**AMENDMENTS TO THE DRAWING**

**REMARKS****DISCUSSION OF DRAWING**

Claim 1 recites an implantable cardiac stimulation lead system comprising at least a pair of conductors that are braided together and extending between proximal and distal ends and co-extruded with flexible resilient insulation material to form a lead body. Each of the conductors comprises a solid core having multi-strand cable and an outer peripheral surface coated with insulative material.

**FIG. 5**

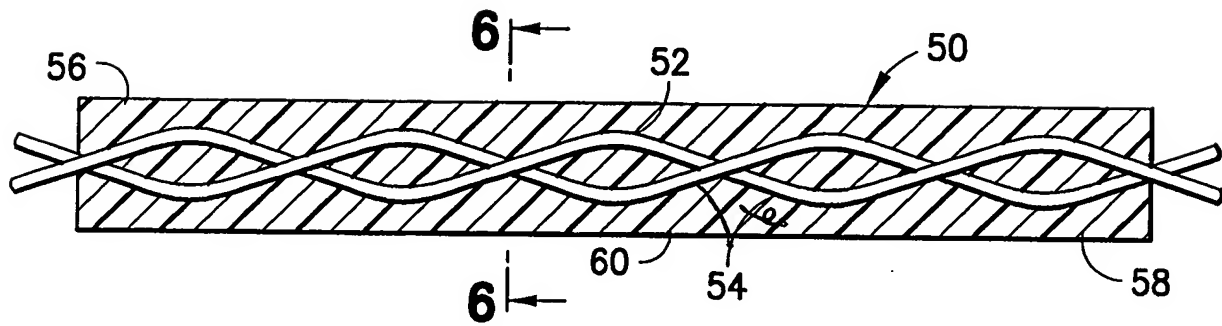
The drawings are objected to because elements 54 and 52 point to the same conductor in Figure 5 and because elements 52A and 54B point to the same conductor in Figure 9. In response thereto, "New Sheets" (Figures 5 and 9) are enclosed herewith in compliance with 37 CFR 1.121(d), wherein elements 54, 52, 52A, and 54B point to different conductors. Furthermore, "Annotated Sheets" are enclosed herewith indicating the changes made to the previous version. Applicants respectfully request acceptance of new Figures 5 and 9.
